Technical BULLETIN

CERTAIN 2015 FJ09F MODELS

Excessive Clearance Between Side Case Stays and Rear Frame

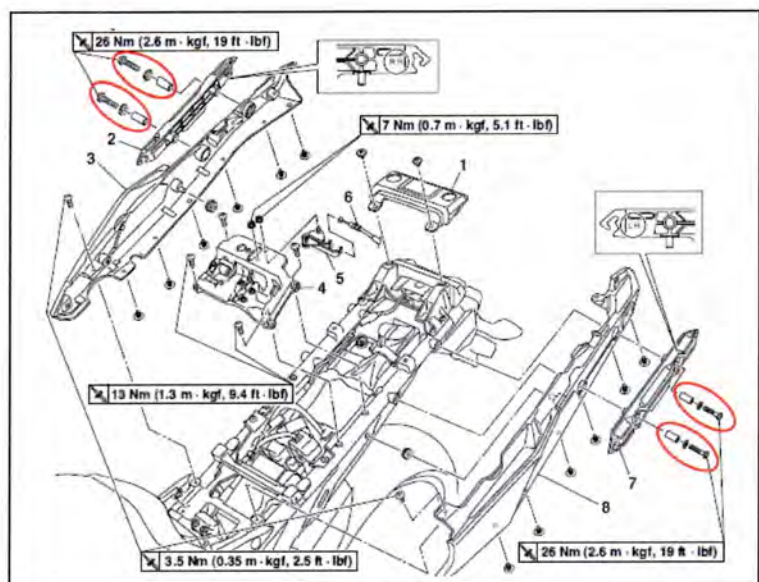
Replace both side case stays by removing the 2 bolts on each side of the unit shown below. Remove and discard the old side case stays. Place the new side case stay into position one side at a time and reinstall the bolts. Torque the fasteners to 26Nm (2.6m-kgf, 19 ft-lb).
